Project Name:	Upper Culham Farm, Henley
Document Reference:	538.0015/DSMP/1
Document Name:	Delivery and Servicing Management Plan
Prepared By:	Luke Rodgers (September 2025)
Checked By:	Laura Jones (September 2025)
Approved By:	Izzie Drohan (September 2025)

- 1.1 This Delivery and Servicing Management Plan (DSMP) has been prepared by Paul Basham Associates to address highway comments (dated 15th August 2025) made by Wokingham Borough Council (WBC) in relation to a full planning application for equestrian uses at Upper Culham Farm, Henley.

Title	PROPOSED SITE ACCESS DESIGN AND VISIBILITY SPLAYS
-------	--

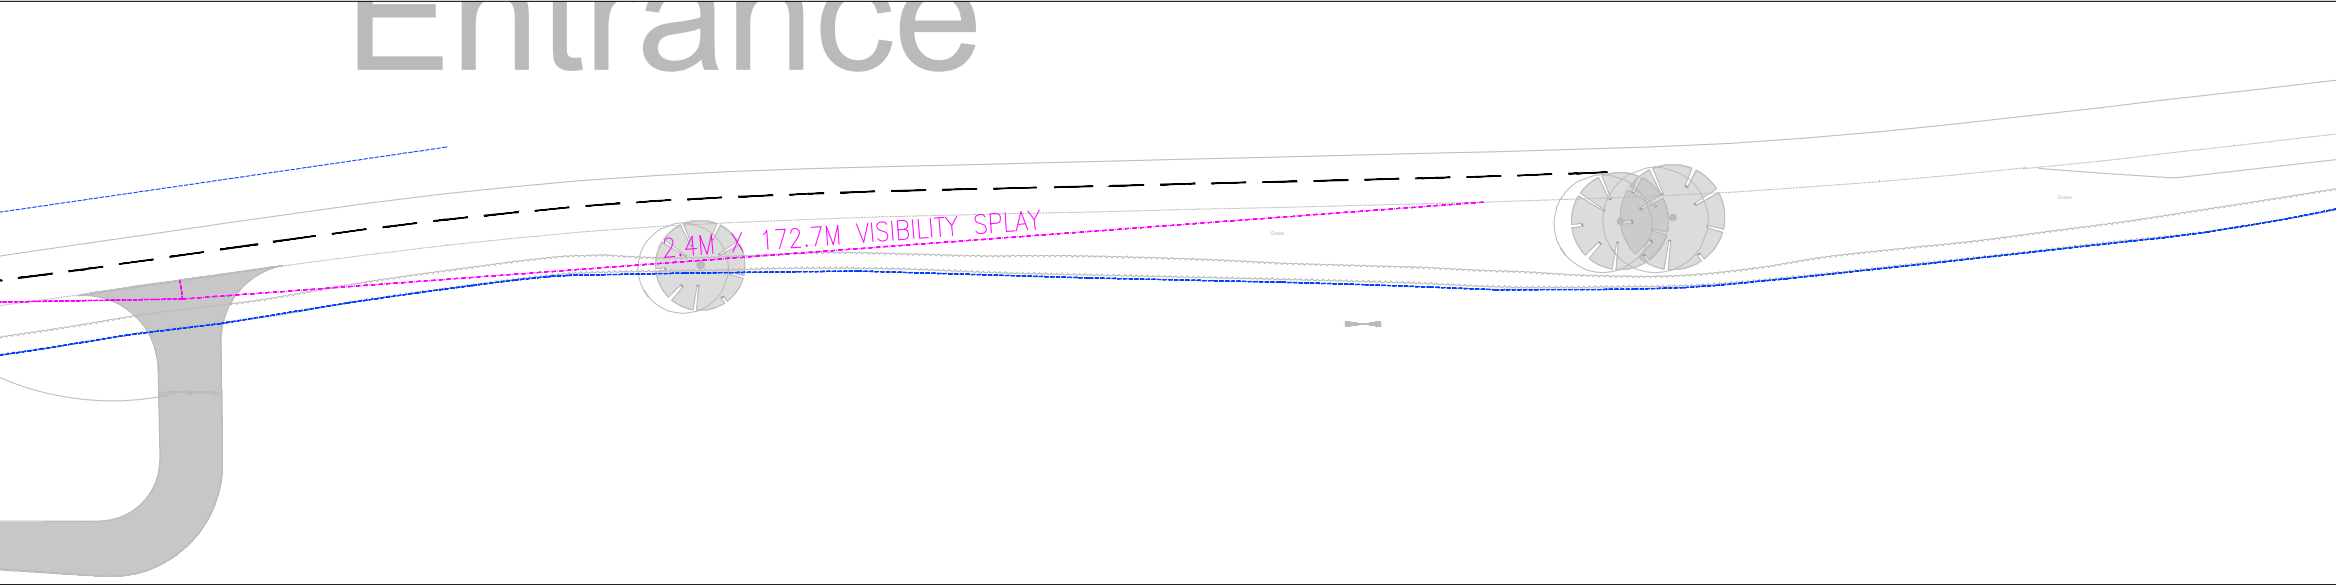
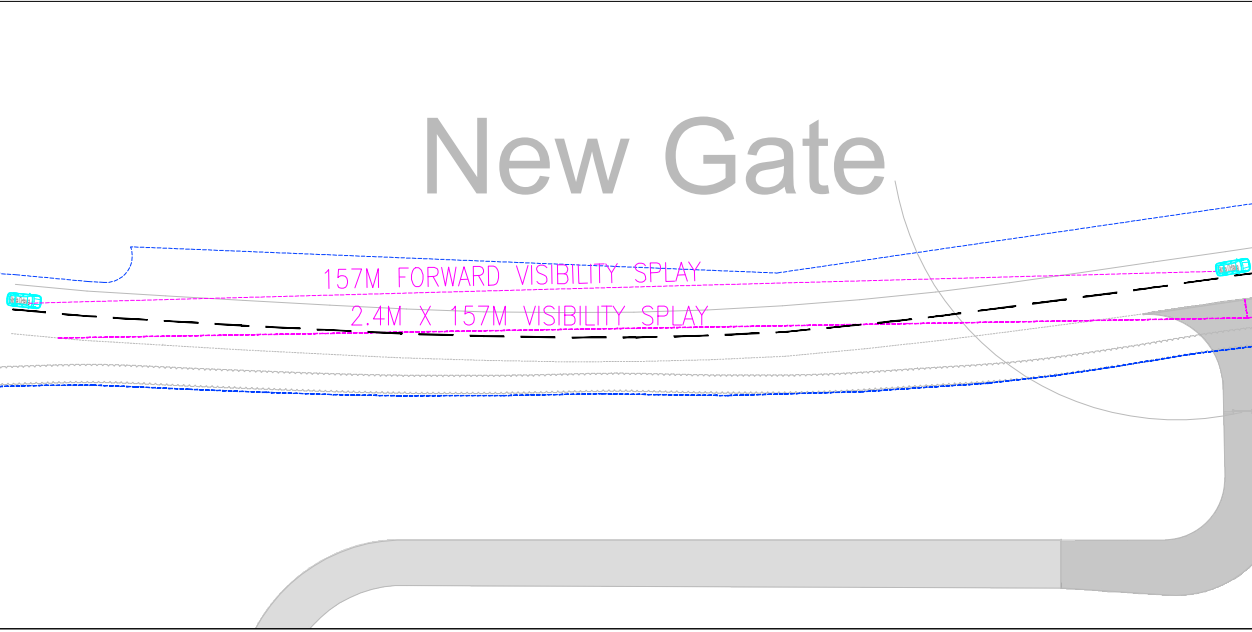
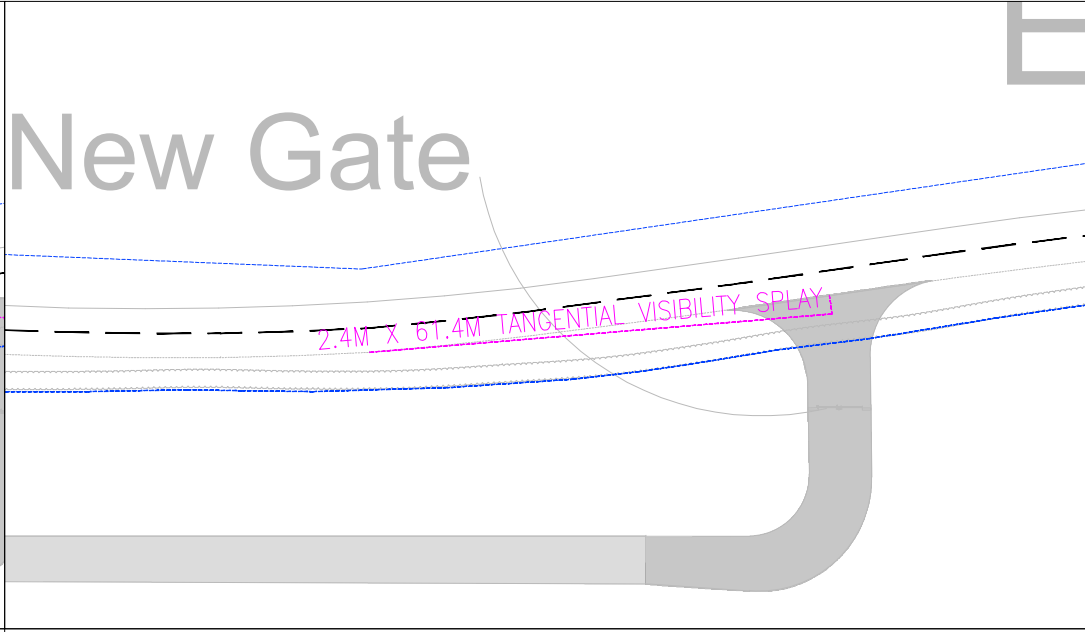
1. The existing site access off Upper Culham Lane will be stopped up.
2. Drawing 538.0015-0001 dated 10th February 2025 demonstrates visibility splays of 2.4m x 155m (to the west) and 2.4m x 172.7m (to the east). It shall be noted that the 85-percentile speed for eastbound is 51.6mph, which requires a visibility splay of 2.4m x 157m to the west. The sightlines shall be across land within the applicant's control or highway land and shall be clear of obstructions to visibility exceeding 0.6m in height.
3. As the proposed site access will be located at a bend, the visibilities shall be assessed along the tangent to a bend in both directions, to ensure that the required SSD on the nearside edge of the carriageway can be provided. The required visibility splay (hatched in yellow) has not been assessed properly.

8. The proposed gate is expected to be set back by the length of the largest vehicle access the site. While Drawing No. 538.0015-0002 has provided the swept path analysis of a 16.5m long articulated vehicle, the gate is proposed to be set back by 15m from the edge of the carriageway, which is insufficient. In view of the traffic flow and speed along the site frontage, the LHA advises to set back the gate by a minimum of 20m to provide sufficient clearance with the A4130.

9. Given the close proximity to the classified A-road, swept paths should demonstrate that the largest vehicle and a large can pass each other, which can unlikely be achieved with the proposed 5m wide access. The proposed access width shall be supported by the swept path analysis.

- 2.1 To address other matters set out within the highway comments, the proposed bellmouth access arrangement has been revised to include an 8.3m access with 10m radii adjacent either side. These geometries support the passing of a 16.5m articulated lorry and car at the access and first bend into the site. Once into the site the internal access road narrows to 6m. A general arrangement plan and vehicle tracking are attached as **Appendix C** and discussed in further detail within the accompanying highway response note.

Title	ARTICULATED AND FIRE APPLIANCE VEHICLE SWEEP PATH ANALYSIS
-------	--

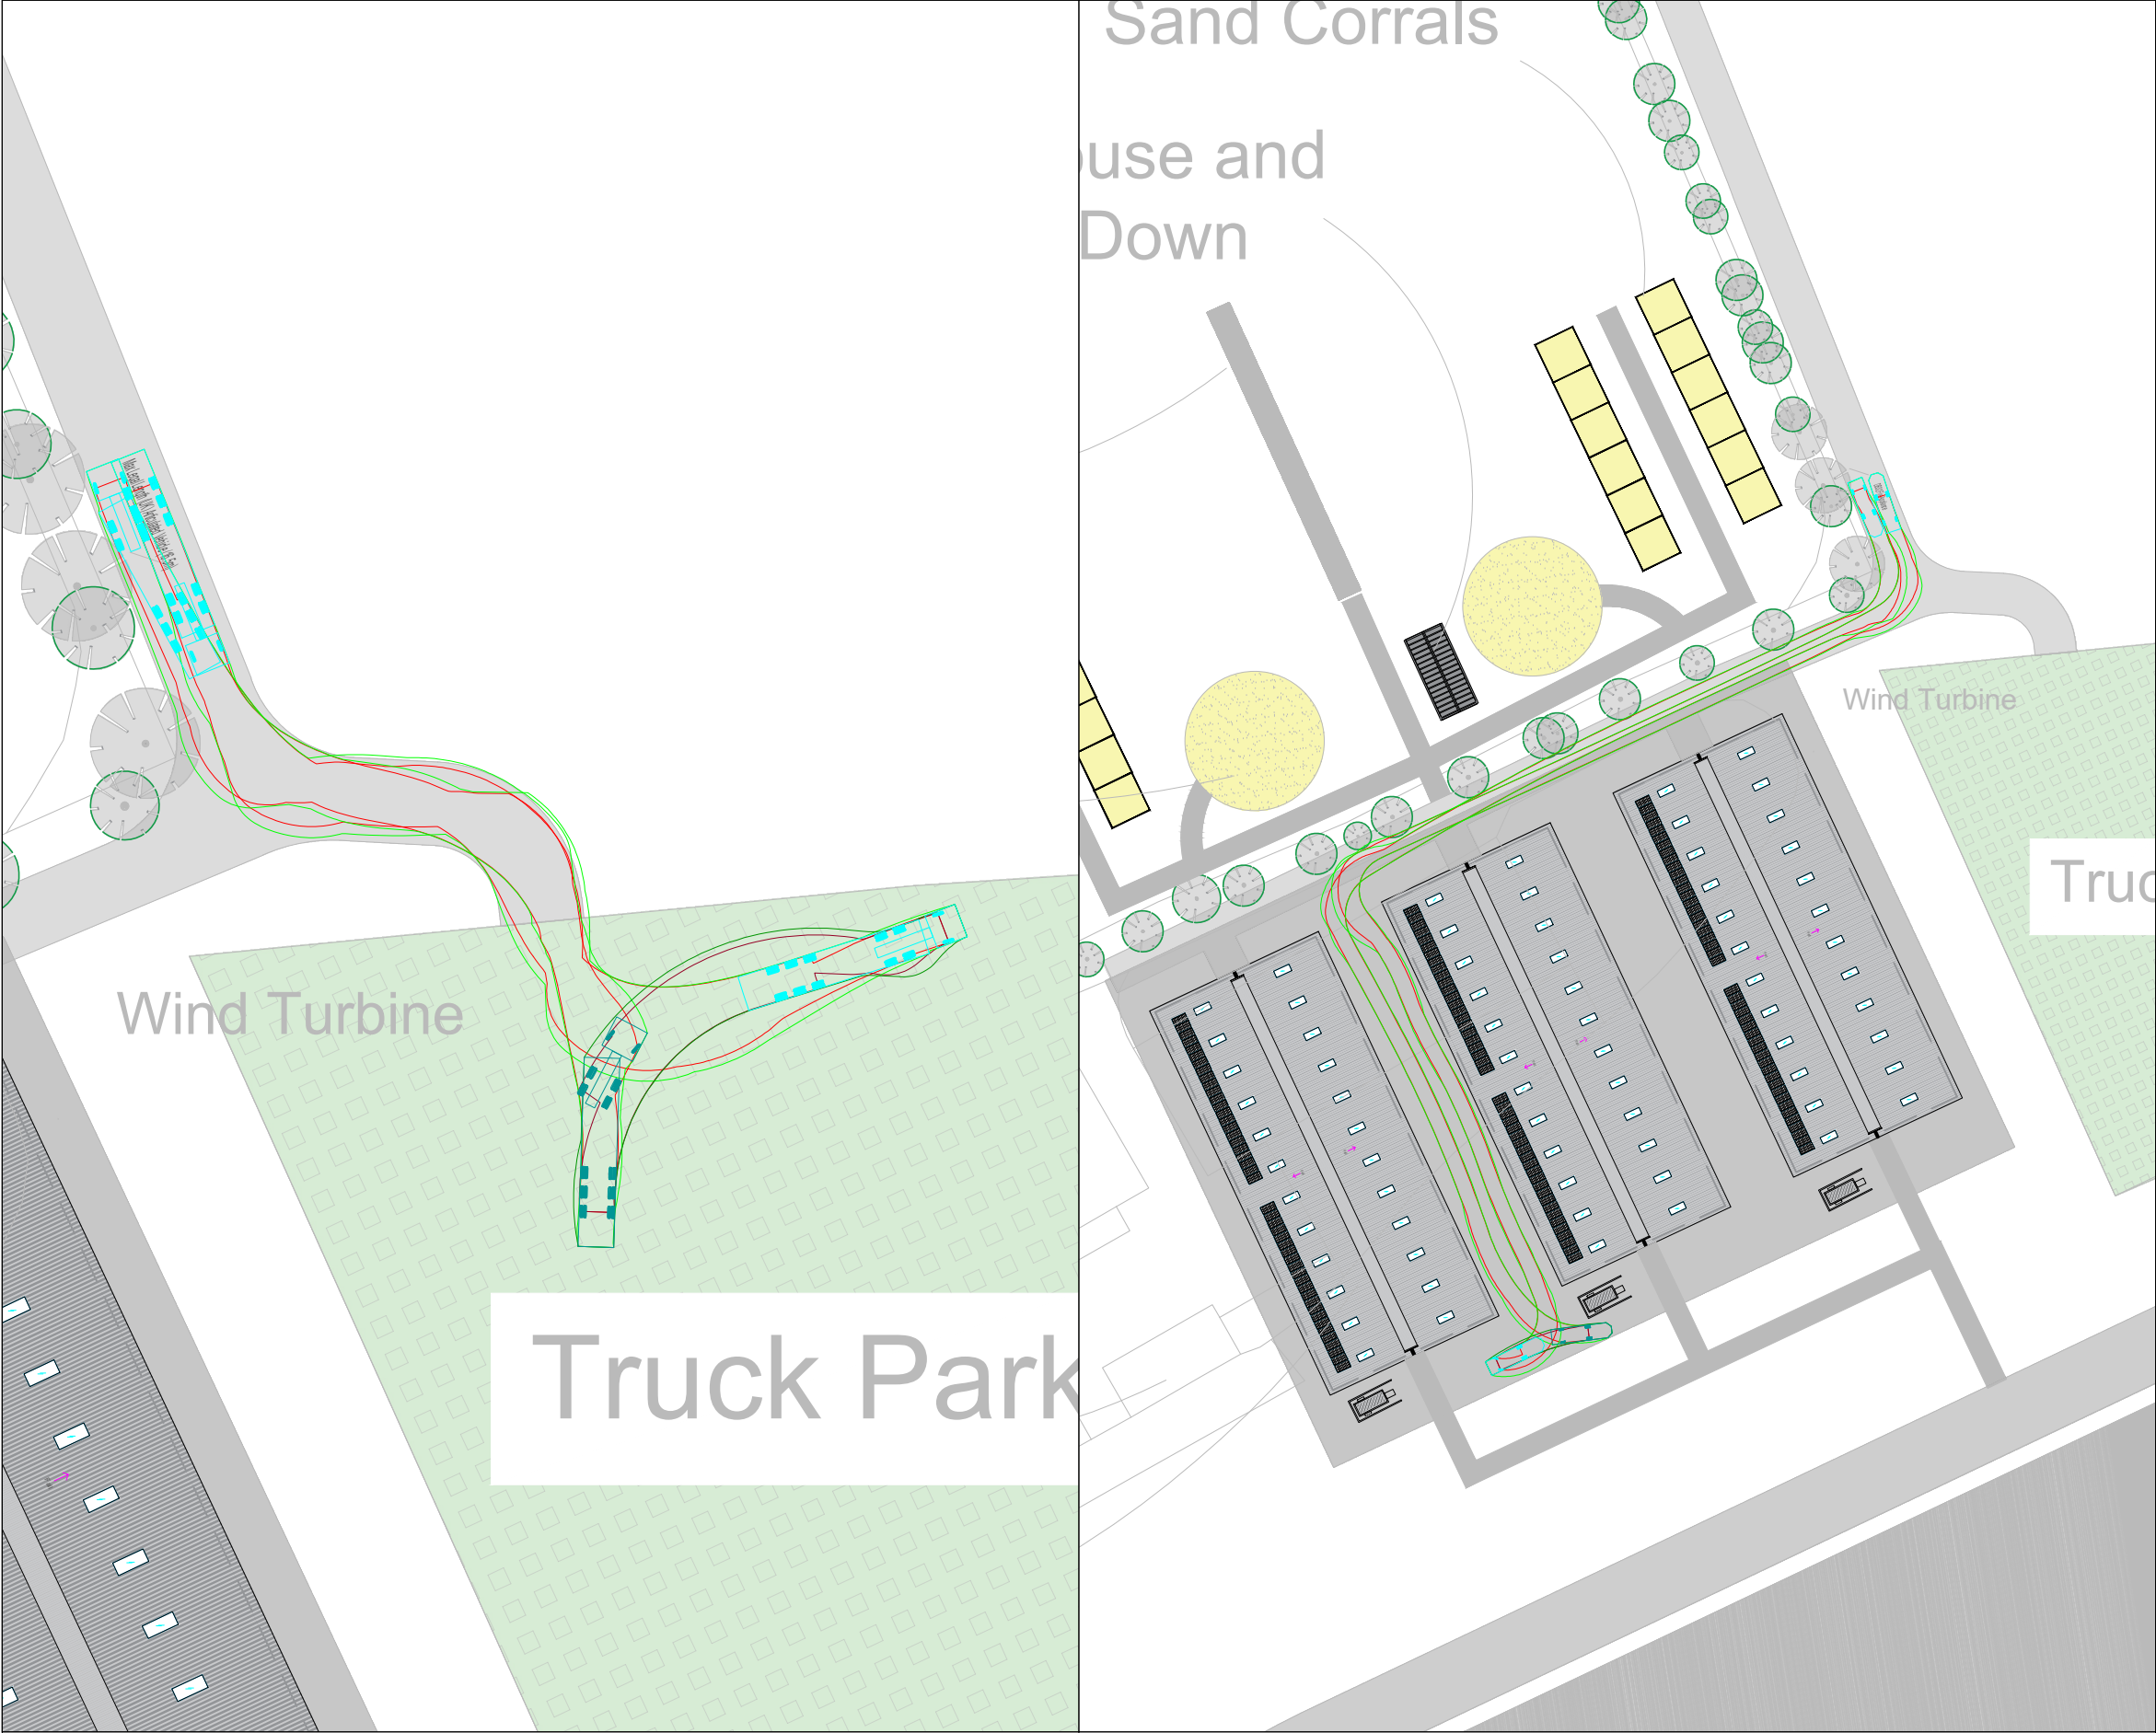
10. The submitted swept paths are required to demonstrate that all proposed vehicles can enter and leave the public highway in both directions and extend to cover the manoeuvring at the first bend (the 90-degree bend).

1. The LHA is concerned if the largest vehicles will be able manoeuvre at the proposed 90-degree bend circa 40m from the edge of the carriageway. The applicant is recommended to review the design.
2. The internal estate roads shall be no less than 6m wide to accommodate two-way traffic of heavy vehicles.
3. If site users are expected to walk between site facilities, a continuous 2m paved footway and suitable crossing facilities are required.
4. 90-degree bends shall be avoided whenever possible.

1. Details of all deliveries, servicing and refuse collection the site will need to be provided. This shall include but not be limited to the breakdown of vehicle types and frequency for all types of delivery and servicing. The applicant may wish to refer to the existing site of similar nature.
2. Swept path analysis of fire tender and refuse collection vehicle shall be submitted.
3. A framework Delivery and Servicing Plan will need to be submitted to ensure efficient delivery of goods, and access by service and emergency vehicles as required in Paragraph 117 of NPPF.

- 4.1 Despite the modest impact of the proposals as a result of the private operation, the proposed development will be served by an internal access road measuring 6.0m wide. Although considered to be a very infrequent occurrence, this is of sufficient width to allow a 16.5m articulated lorry and car to pass along the straight sections. Turning facilities have been provided onsite including sufficient space within the truck parking provided to the southeast of the site to accommodate a 16.5m articulated lorry as a worst case in addition to suitable turning space adjacent the American Barns to accommodate a fire tender and enable it to get within 45m of all parts of the building as per Building Regulations. Vehicle tracking of a fire tender and 16.5m articulated lorry is attached as **Appendix E**.
